Agenda Item: Contract Change Order No. One; AIP 3-08-0030-051-2

Gunnison-Crested Butte Regional Airport
Gunnison, Colorado
AIP 3-08-0030-051-2016
Change Order No. One

CONTRACT CHANGE ORDER NO. 1 **or** **SUPPLEMENTAL AGREEMENT NO.** N/A

REHABILITATE ASPHALT
RUNWAY 6/24

SHEET NAME C302

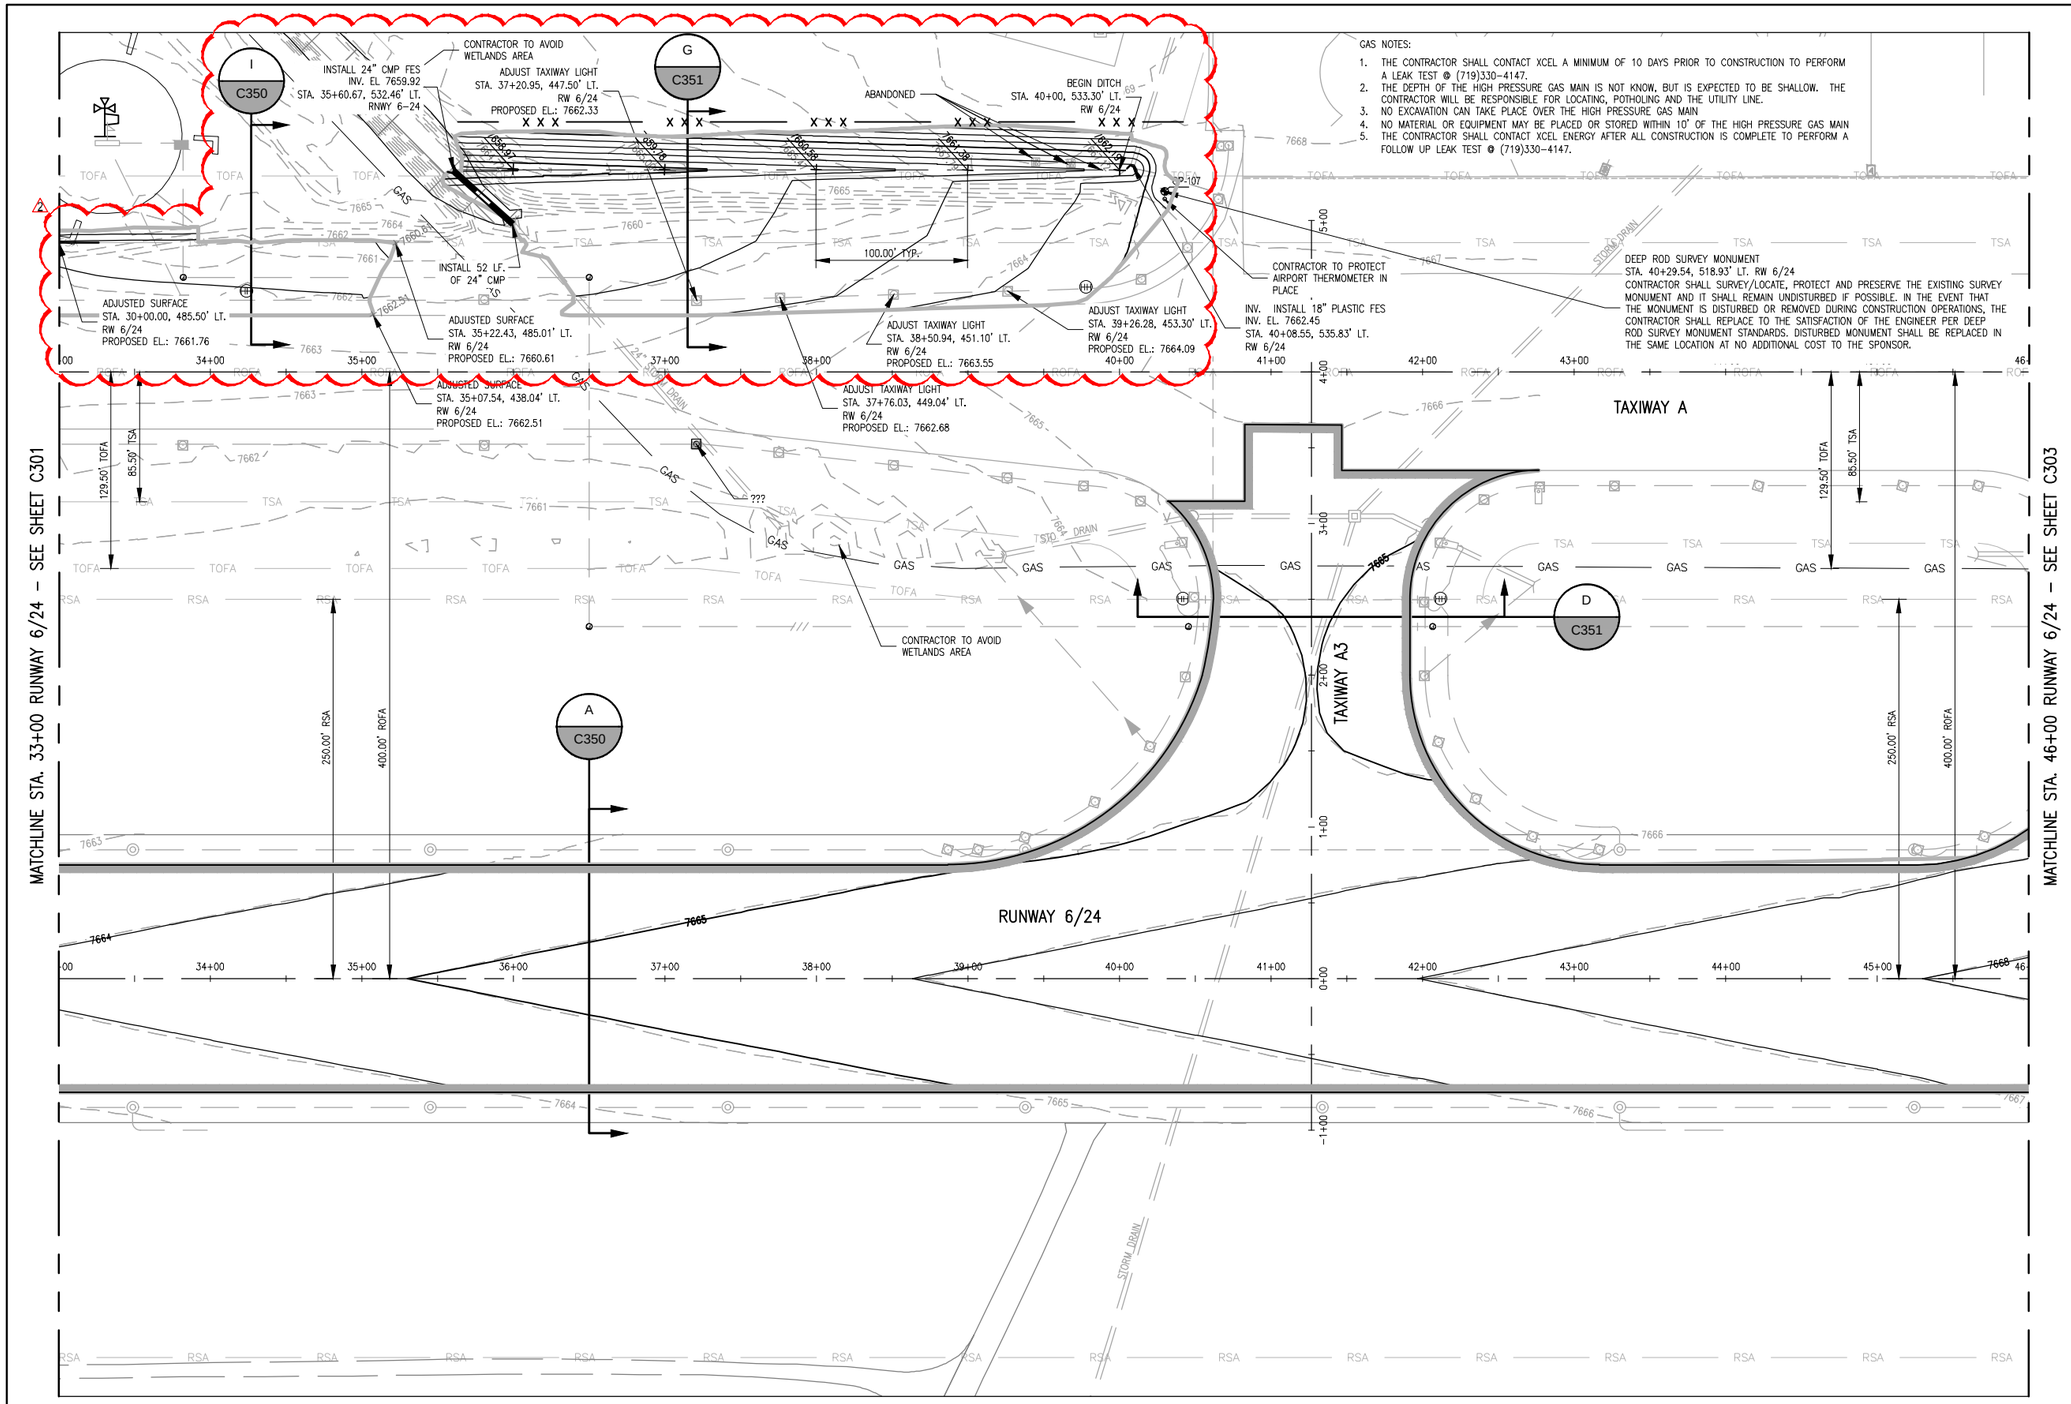
- Utility Pothole – Removed potholing on top of Xcel Energy high pressure gas line.

- Grading Changes – Removed grading above Xcel Energy high pressure gas line.

- Utility Pothole – Excel Energy did not require potholing to obtain depths of the high pressure gas line

- Grading Changes - Removing the grading over the Xcel Energy high pressure gas main will eliminate the need to coordinate with Xcel Energy. The portion of work associated with the gas main was becoming a risk to the project schedule and budget based on new information provided by Xcel Energy at the pre-construction meeting.

SHEET NAME C600

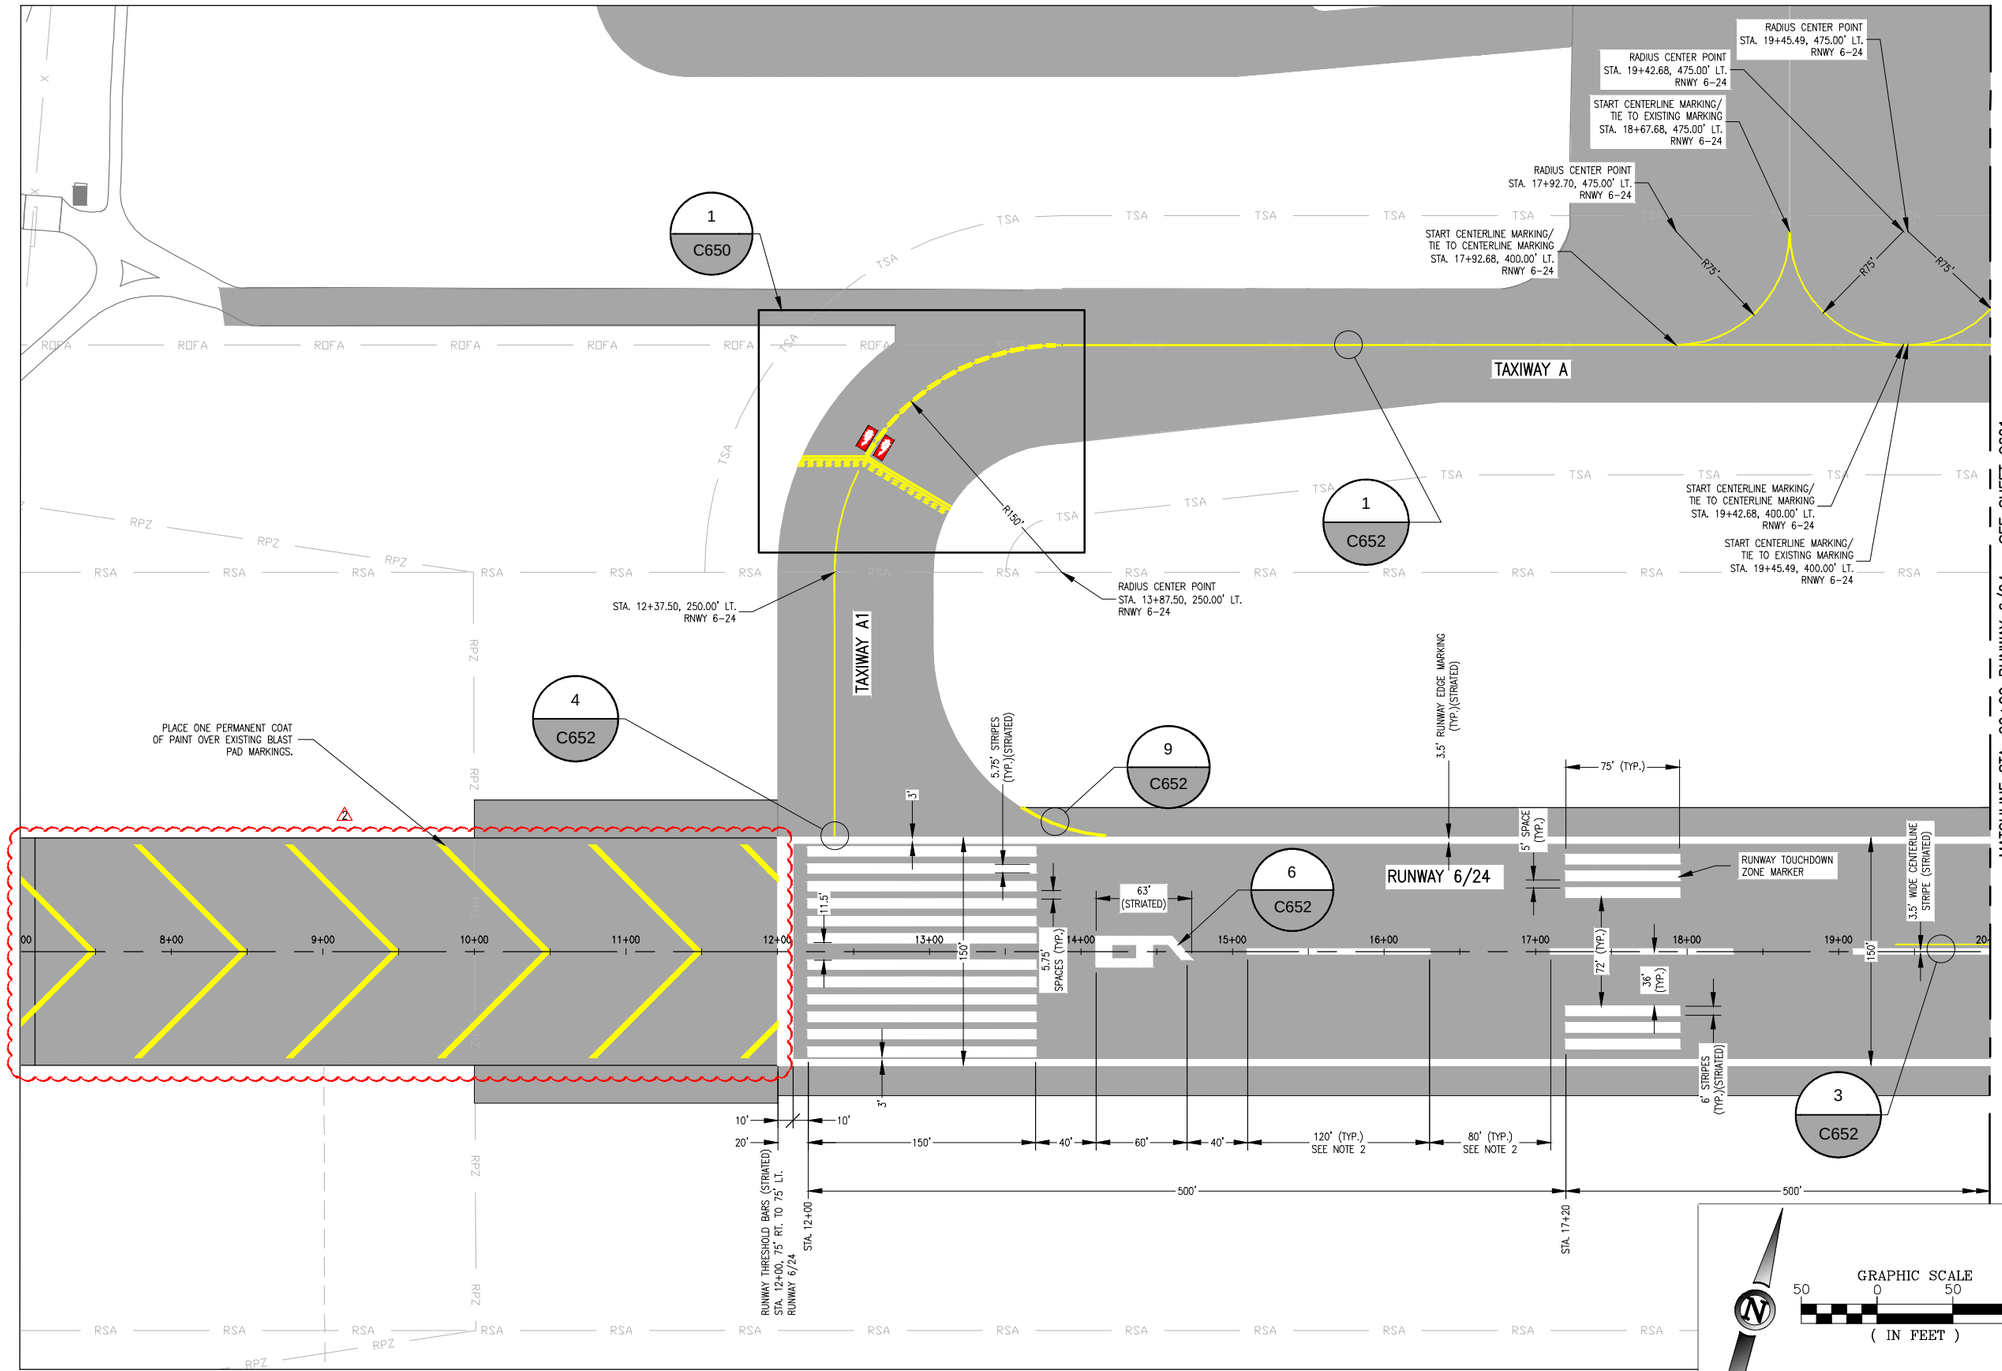
- Additional Painting for Blast Pads – The blast pads are in need of remarking have been added into the project.

- Additional Painting for Blast Pads – Upon discussions with the FAA and the Sponsor, it was determined that pavement markings should be added to the project.
